September 11, 2021

Subject: Submittal of Comments on Final Environmental Impact Statement (FEIS) for Interim Storage Partner's (ISP's) License Application for a Consolidated Interim Storage Facility (CISF) in Andrews County, Texas, Docket ID NRC-2016-0231

Final Environmental Impact Statement Review for Consolidated Nuclear Storage Facility, Andrews County, TX

Figure 2: Cumulative Impact Radii from ISP FEIS (NRC 2021)

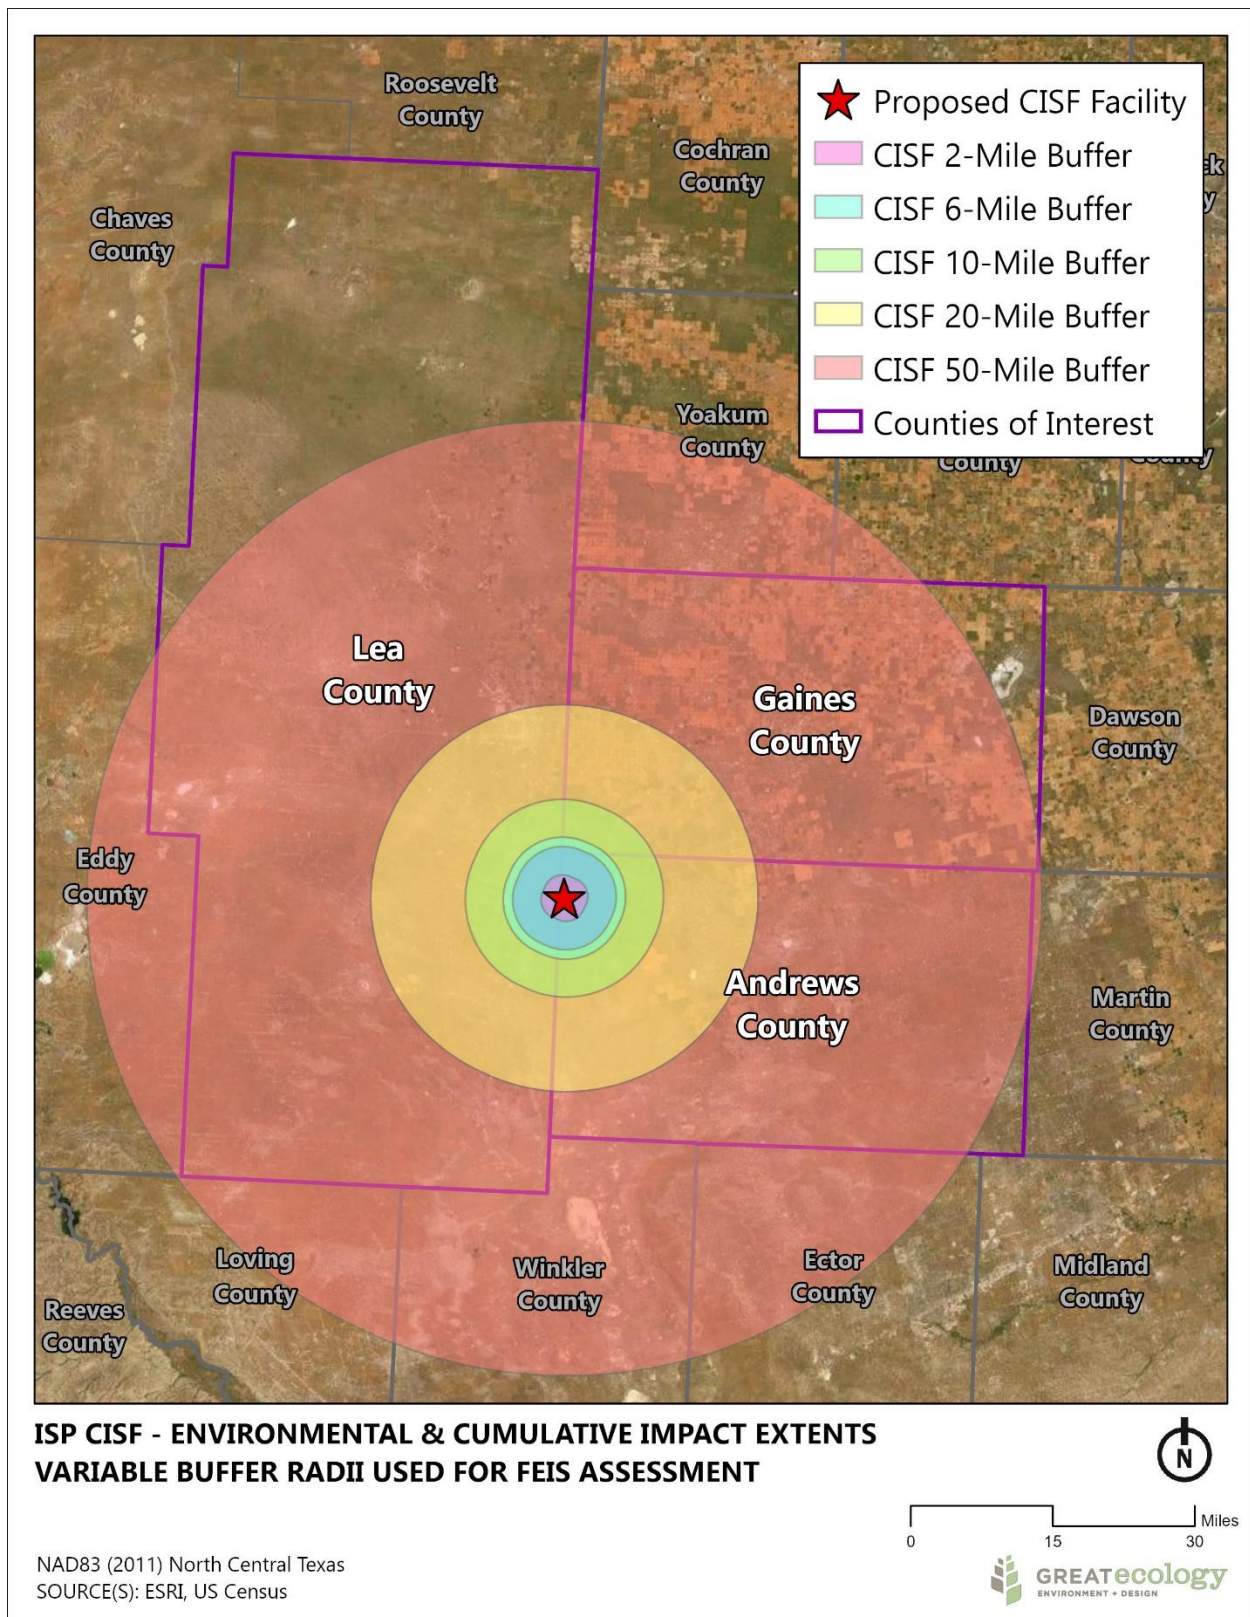
The FEIS arbitrarily identifies a 20-mile cumulative impact evaluation radius for groundwater from the ISP Project. The FEIS further states that, of the nuclear facilities in the region only the existing Waste Control Specialists (WCS) facility, National Enrichment Facility (NEF), and Eden Radioisotopes are within the 20-mile groundwater study area. By arbitrarily limiting the study area dimensions, thorough evaluation of cumulative impacts of ISP and other past, present, and reasonably foreseeable projects to groundwater resources are precluded. As the Permian Basin Coalition and Fasken Land and Minerals' previous comments on the ISP draft EIS (PBLRO & FLML 2020) noted, the geographic formation (Central Basin Platform) is heavily-faulted and the Project's seismic hazard analysis was deficient. The PBLRO/FLML letter also calls attention to the ISP environmental analyses' failure to mention and characterize the Rio Grande Rift (RGR), which it characterizes as critical in understanding the geological and geohydrological history of the aquifers at the CISF and potential risks to groundwater resources and seismology (PBLRO/FLML 2020). In light of the analysis' arbitrarily limited spatial scale in a region of obvious seismic risk, evaluation of cumulative impacts to groundwater resources is clearly inadequate.

Once again, the FEIS arbitrarily identifies a small, 5-mile cumulative impact evaluation radius for wildlife from ISP Project. NRC states that their ecological cumulative impacts analysis is "limited to this radius because ecological resources are not anticipated to influence or to be influenced by the proposed CISF project outside of this area." This statement is not supported by any real scientific evidence and does not consider the wide ranges of several species with the potential to occur onsite. Migratory birds would most certainly be impacted outside of a 5-mile radius from the project, along with any highly mobile species.

Figure 3: Nuclear Reactor Sites throughout the United States and Nationwide Railroad Network

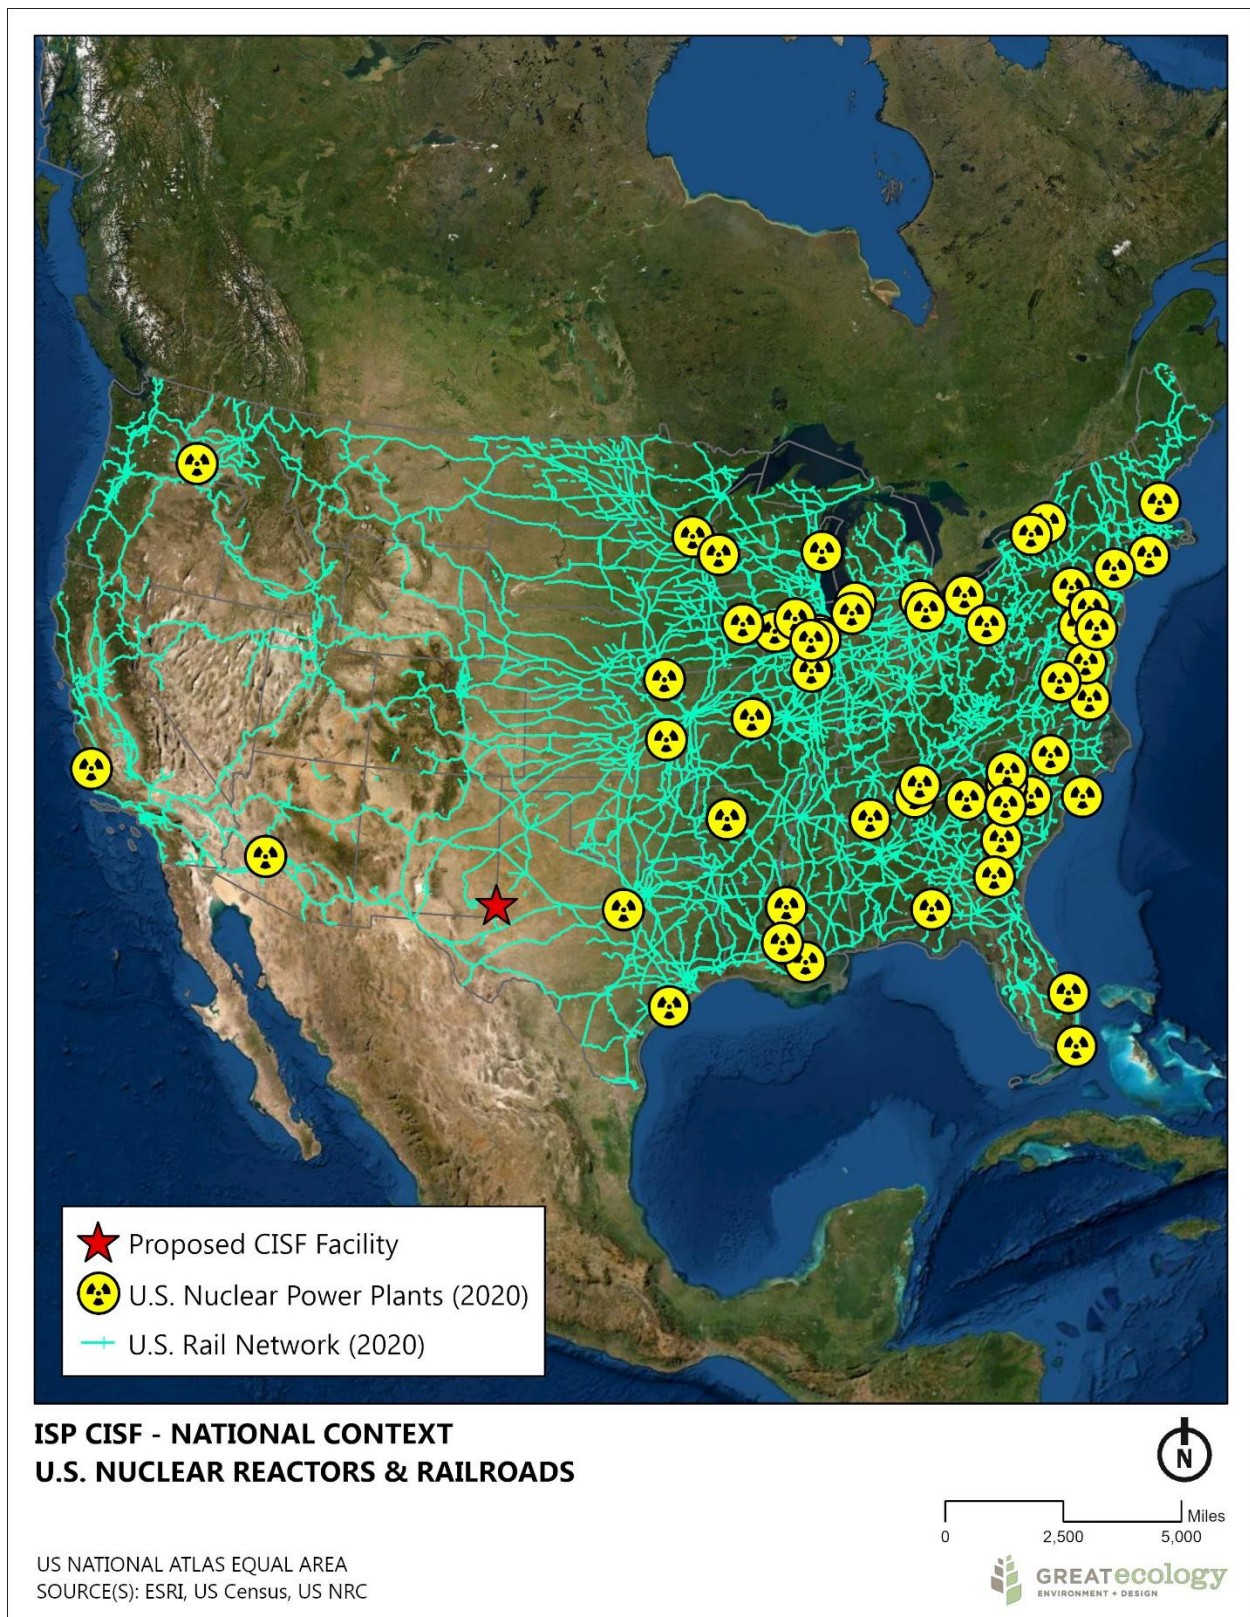
The FEIS also downplays the nationwide extent of where HLW would be arriving from, since HLW is currently stored at nuclear energy facilities dispersed throughout the country. FIGURE 3 shows the locations of nuclear reactor sites across the US, along with the railroad network that would need to be utilized to transport waste currently existing at these sites. Illustrations and figures in the FEIS do not show the true breadth of this problem, and instead separately show the rail network and decommissioned nuclear power plants (FIGURE 4). HLW is spread throughout the country, and the extent of its transportation to the ISP CISF facility has a much larger impact (and would be more than 'incremental') than the FEIS presents. It also ignores what the surrounding local community looks like, and what sensitive receptors could be most impacted. FIGURE 5 depicts several facilities with vulnerable populations in the area (an extrapolation of the rail network presented by NRC in FIGURE 4); many of these sensitive receptors are located quite close to the railroads in the area. Should any accident occur in the future, these people would certainly be impacted quite heavily.

Figure 6: Current Species Ranges for Northern Aplomado Falcon and Pronghorn Antelope

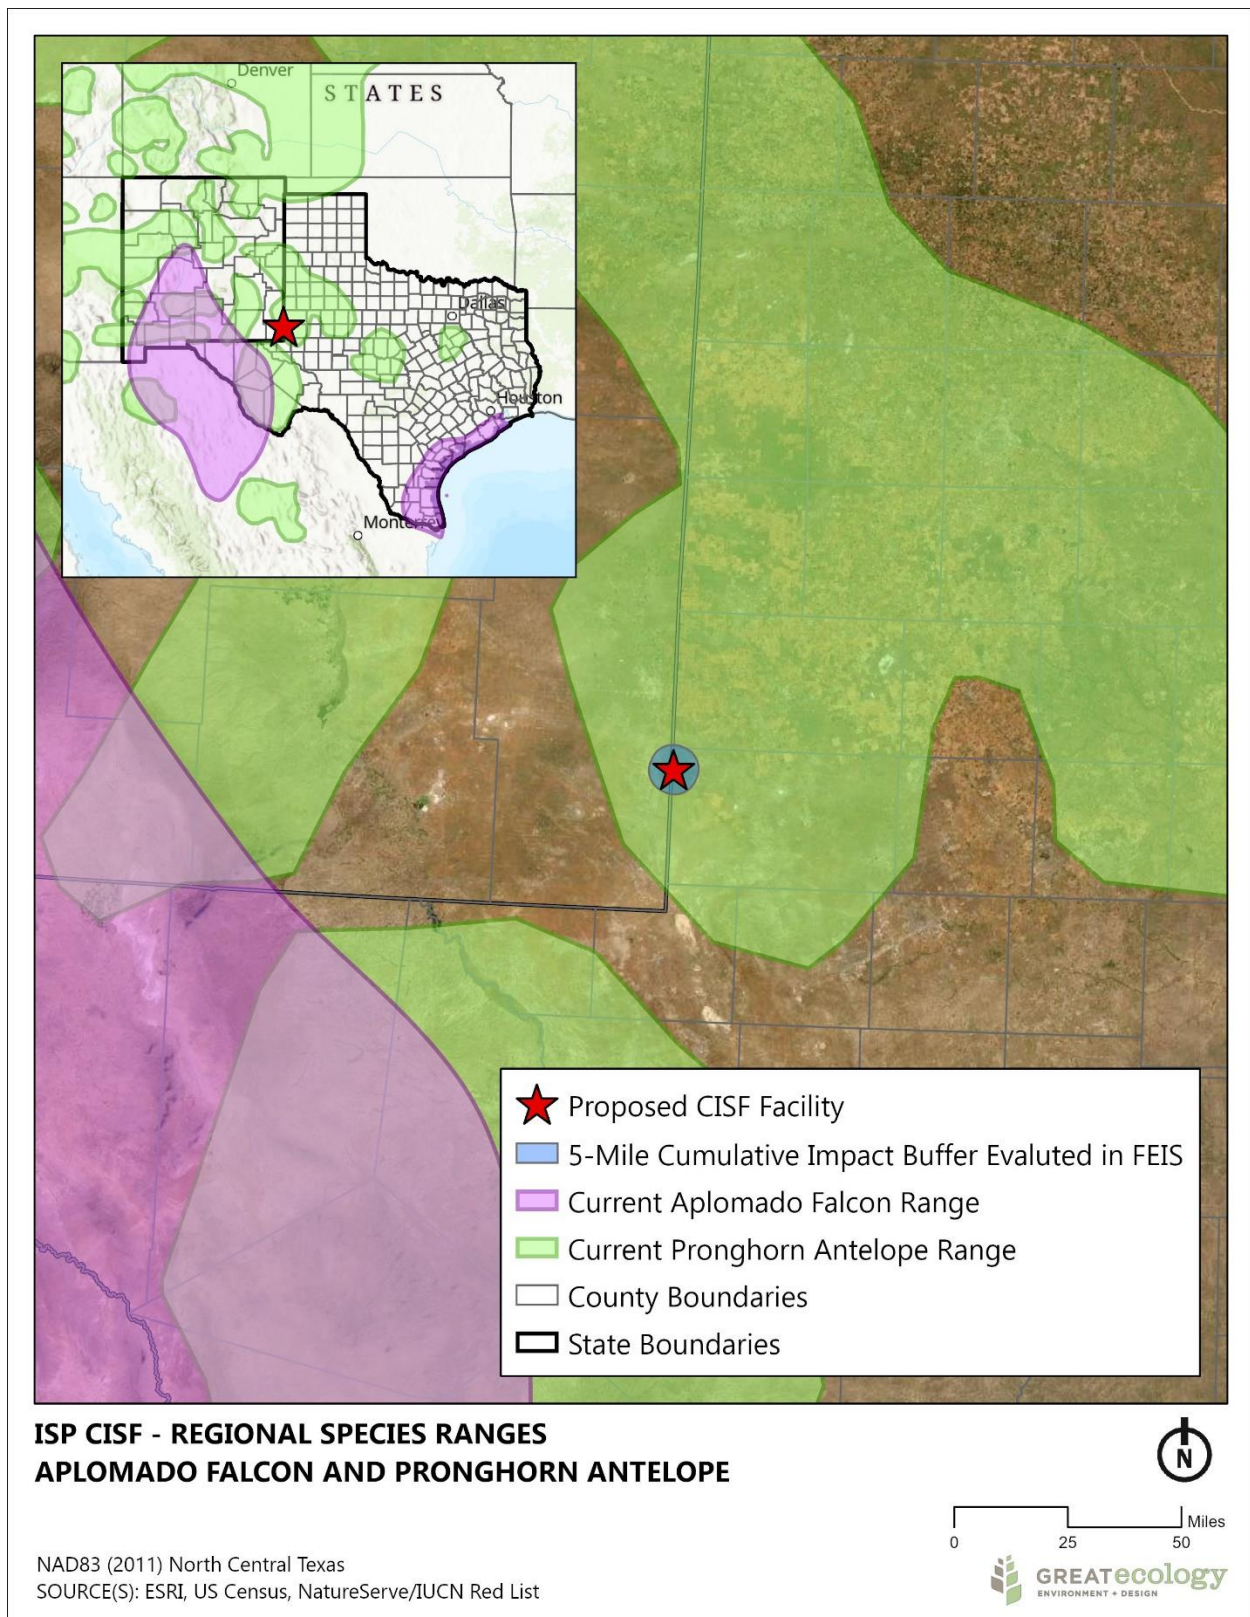
We discuss two species with wide-reaching ranges that were not examined thoroughly as part of the ecological cumulative impacts analysis: the endangered northern Aplomado falcon (*Falco femoralis septentrionalis*), and a regionally important game species, the pronghorn antelope (*Antilocapra americana*). Both species have a much wider reaching range than five miles, which is not captured by the FEIS cumulative impact radius (FIGURE 6).
